Date October 13, 2021
To Town of Cumberland Planning Board
From Carla Nixon, Planning Director
Subject: Site Plan Review: Greely Road Gravel Pad Expansion

Subject: Peer Review of the Site Plan Review Application
Town Gravel Pad Storage Area
Greely Road, Cumberland, Maine

Drawing No.
2

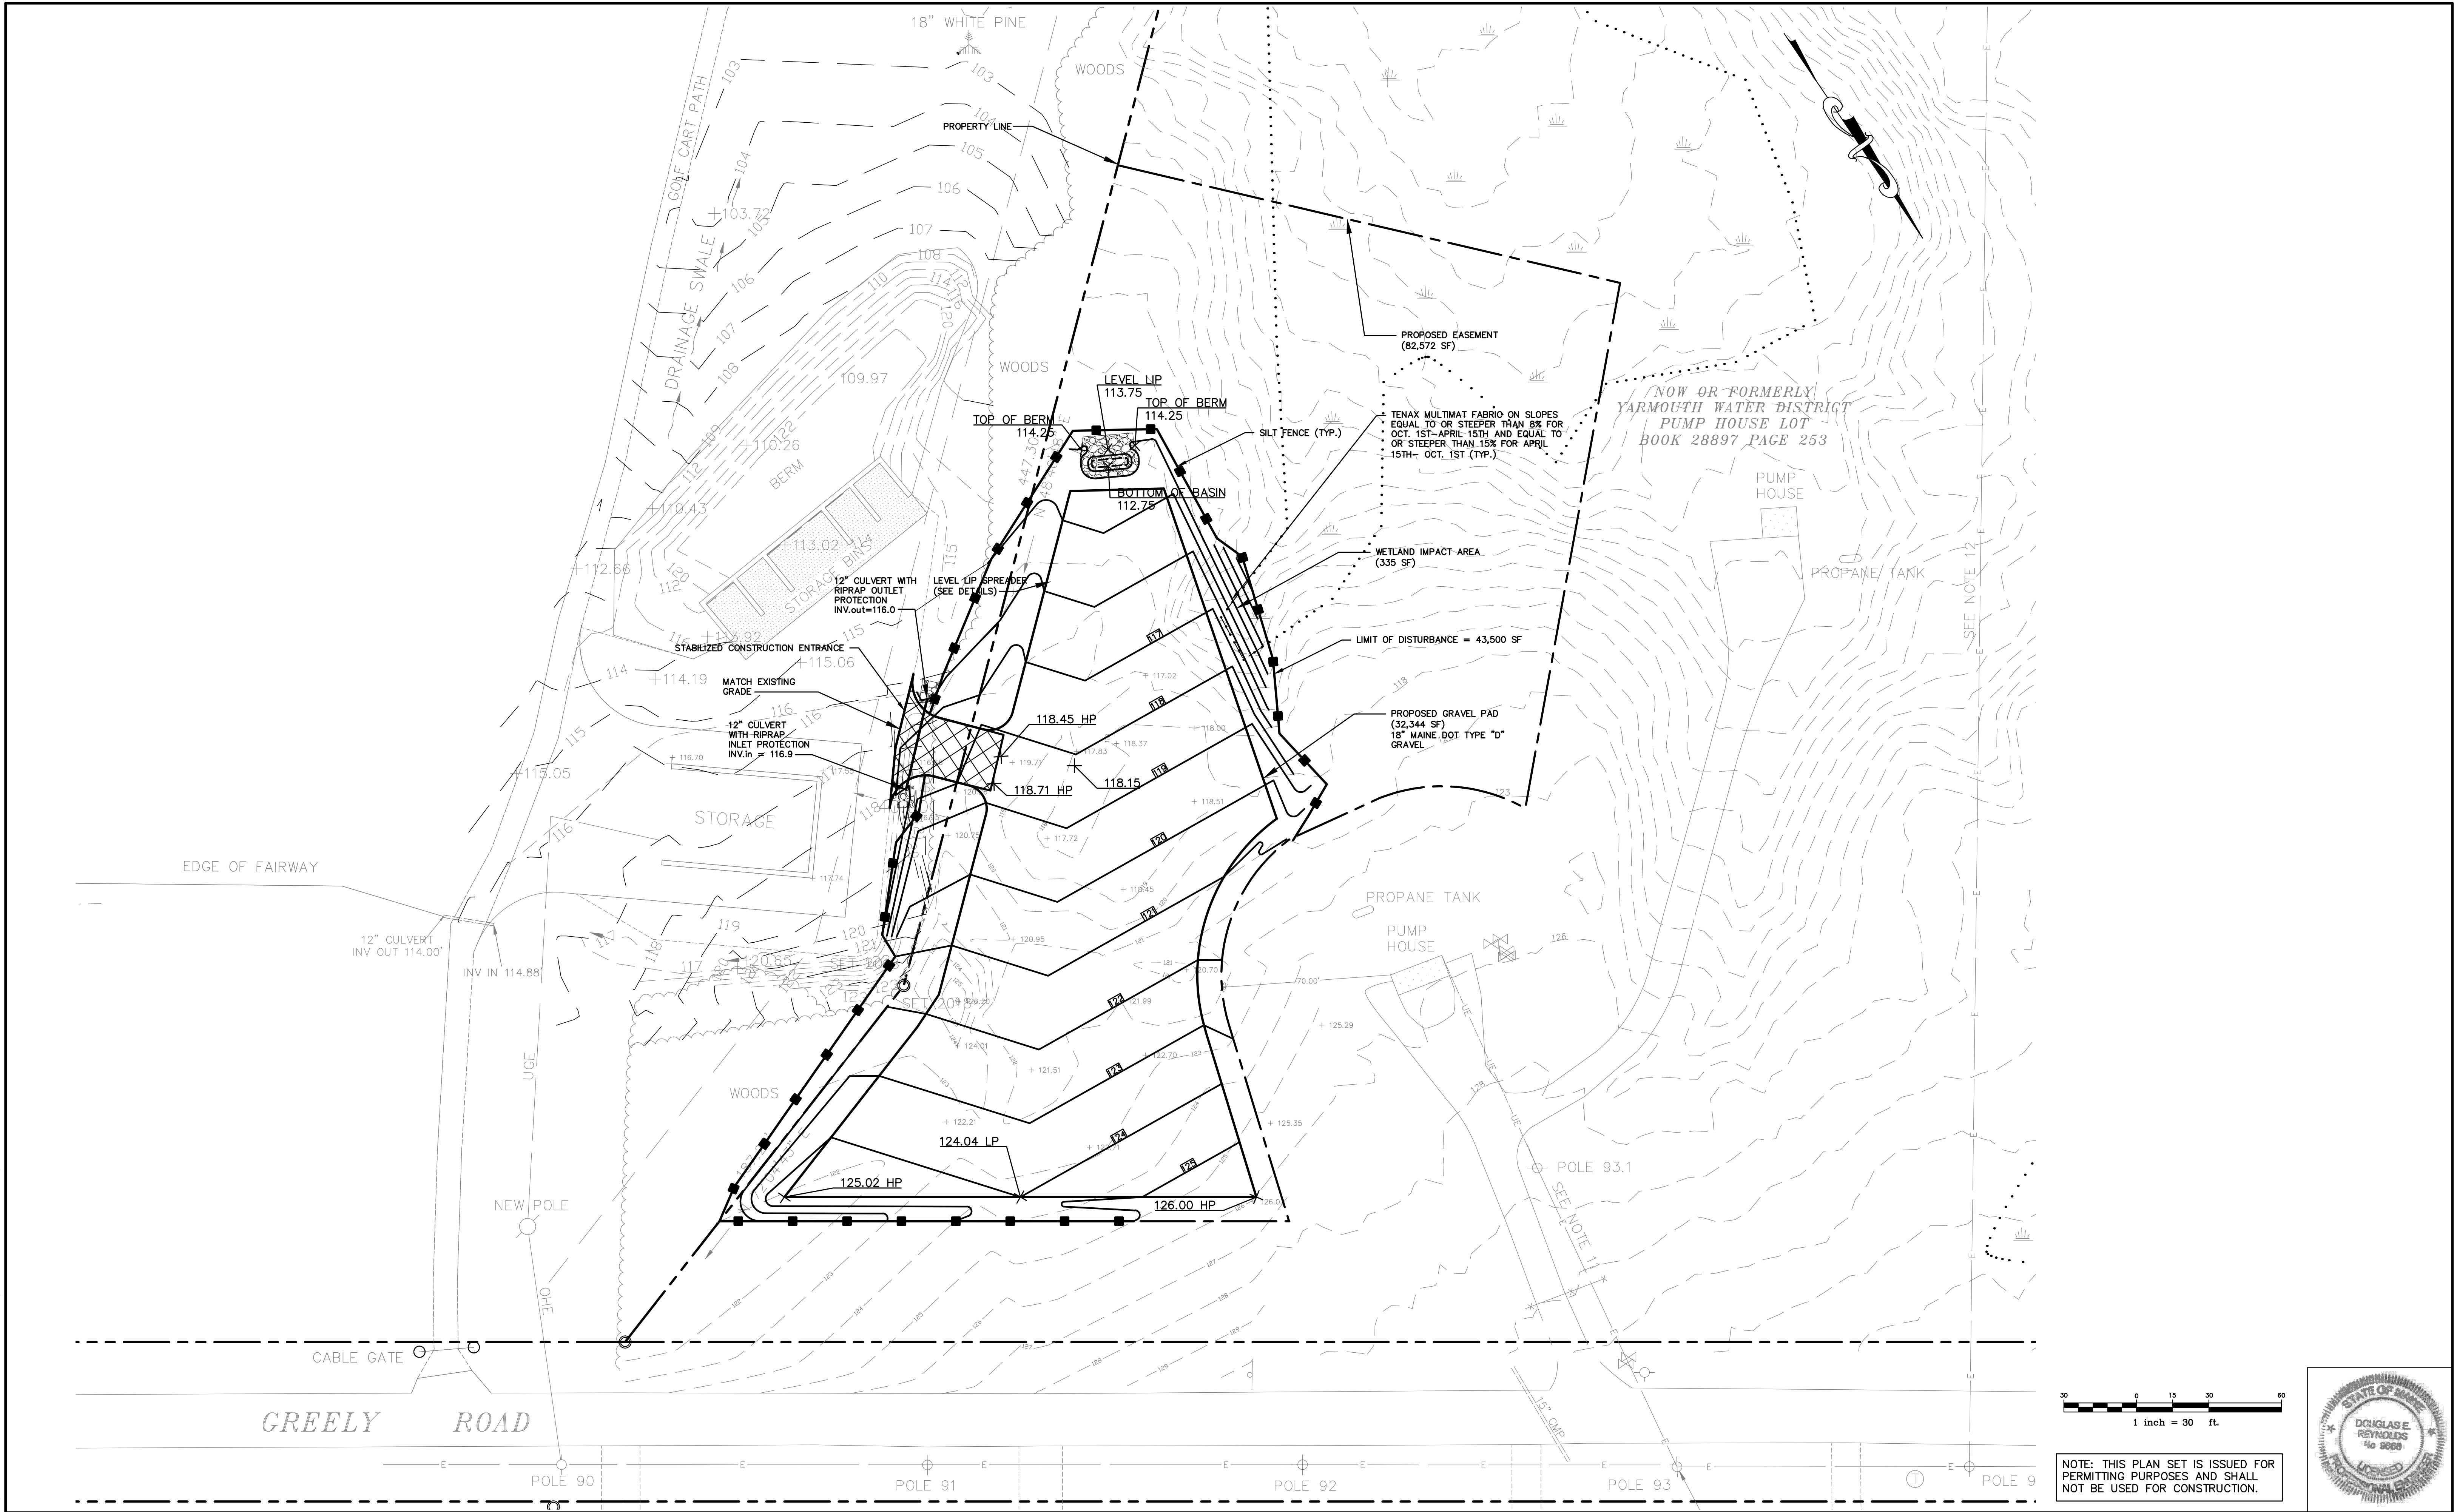
1. The limit of site disturbance appears to exceed one acre of area with the 43,475 square foot gravel pad and associated side slopes. Projects that disturb more than one acre require submission of a Maine Department of Environmental Protection Stormwater Management Permit by Rule. Please indicate if the project will submit the PBR application, or resize the limit of work to be less than one acre. **The area of the gravel pad has been reduced to approximately 0.8 acres, such that the developed area is under 1 acre**
2. Please provide stormwater runoff calculations to demonstrate that the level spreader will control post-development peak flows to the pre-development peak flows. **Stormwater calculations have been provided, showing that the post development flows are below predevelopment flows for the 2, 10 and 25 year storms**

3. The application notes that the equipment storage on the pad will be covered to avoid any potential run-off, seepage, or percolation into surface water or groundwater. Please provide information on the type of equipment stored on the gravel pad and how it will be covered.
